# AEROPRAKT SERVICE BULLETIN

No. SB A32-02

## MODIFICATION OF ALL-MOVING HORIZONTAL TAIL (AMHT) OF A32 AND A32L AIRCRAFT

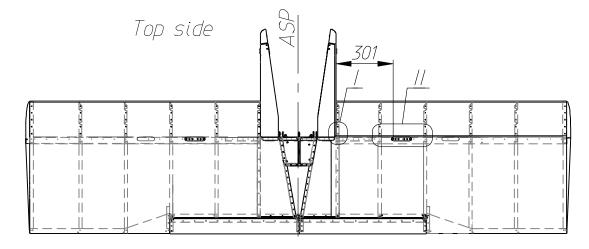
Inspect the AMHT in the area of mod kit parts installation (see detail views II and IV in fig. 1 and 2) for dents, deformation and cracks. If any damage is found in the above mentioned areas consult the manufacturer.

◆ NOTE: Inspect the lefthand and righthand portions of the AMHT, on both top and bottom side.

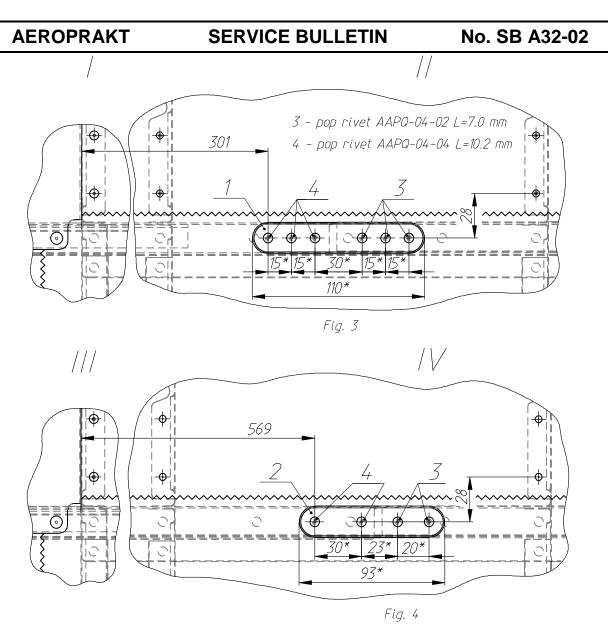
- Fig. 2
- 1. Installation of the top (righthand and lefthand) doublers:
- 1.1. Mark 2 holes (1 per righthand/lefthand side) on the top side of the AMHT at 301 mm distance as shown in fig. 1 and 3.
- 1.2. Drill the 2 marked holes with  $\emptyset$ 3.3 mm drill bit.
- 1.3. Install the doublers (1) on Cleco fasteners symmetrically about the aircraft symmetry plane (ASP).
- 1.4. Using the holes in the doublers as pilot holes drill  $\emptyset$ 3.3 mm holes 5 holes on each (righthand/lefthand) side.
- 1.5. Remove the doublers, deburr/blunt the sharp edges of the holes, remove the metal chips.
- 1.6. Attach the doublers with pop-rivets (3) and (4) as shown in fig. 3 (symmetrically about the ASP).
